Drain: WALROND ROAD DRAIN **Drain #:** 119
Improvement/Arm: WALROND ROAD - SECTION 2
Operator: JDH **Date:** 7-30-04
Drain Classification: Urban/Rural **Year Installed:** 1986

RE: Walrond Road Drain

RE: Walrond Road Drain-Section 2

WALFROND ROAD, SECTIONS ONE & TWO "As Built" Site Development Plan		SHEET
	Frank M. Hahn & Associates, Inc.		OF
	Engineers	Surveyors	
DWG. BY: <u>JPH</u>	CR. BY:	DATE: <u>11-2-07</u>

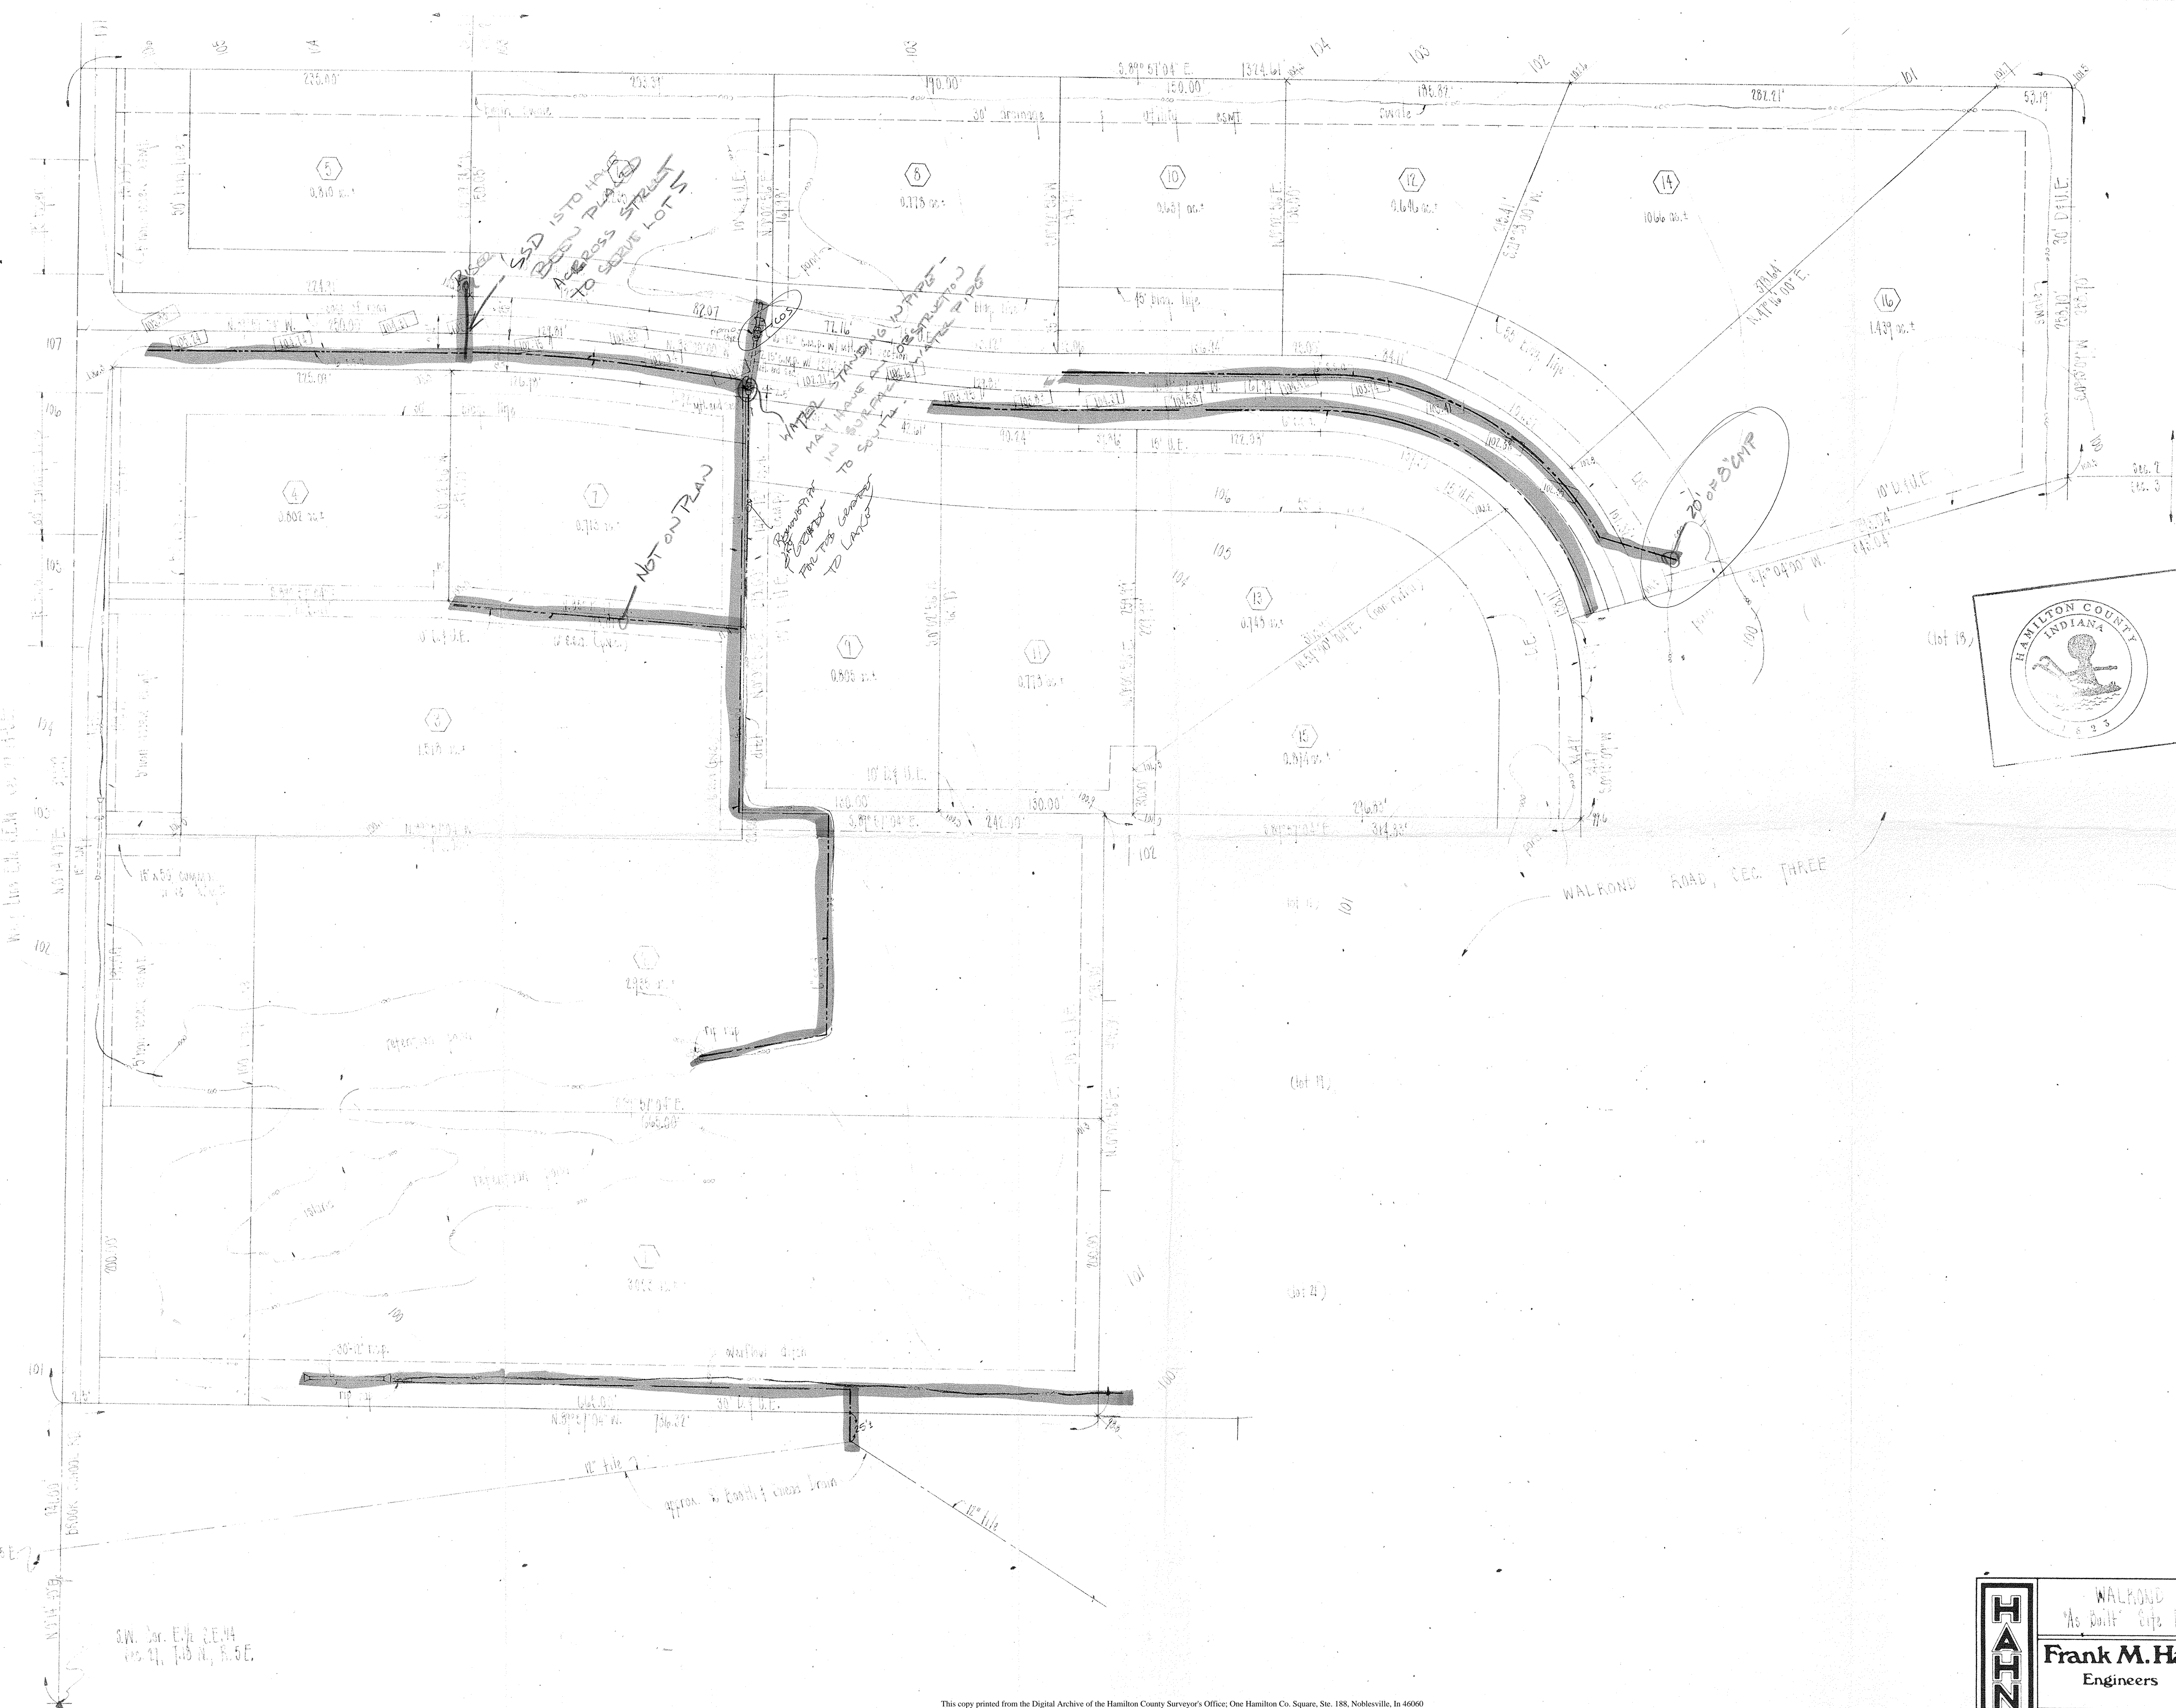
During construction, changes were made to the drain which will alter the plans submitted with my report for this drain dated June 9, 1986. The changes are as follows:

- 16ft of 12" RCP serving as outlet of pond on Lots 6 and 8.
- 5ft of open RipRap drain between pond outlet above and street
- 190ft of 6" SSD added between Lot 3 and 7.
- 460ft of 6" SSD added to North side of Street, stubs not placed
- 20ft of 8" CMP added to 6" SSD outlet into pond on Lot 16.

The length of the drain due to the changes described above is now 1161 feet.

^{1211'}
The ponds are not part of the regulated drain and are the responsibility of each homeowner.
